HARROW COUNCIL

SUPPLEMENTARY ADDENDUM

PLANNING COMMITTEE

DATE: 18th November 2020

1/01

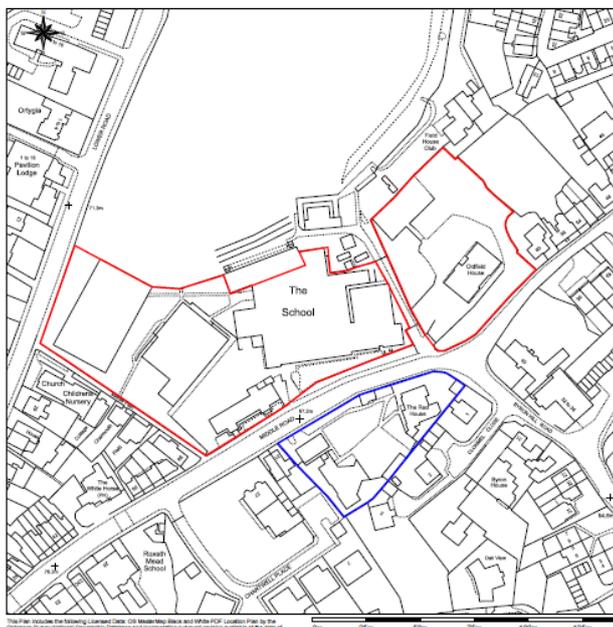
Replace Site Plan on page 20 with the following:
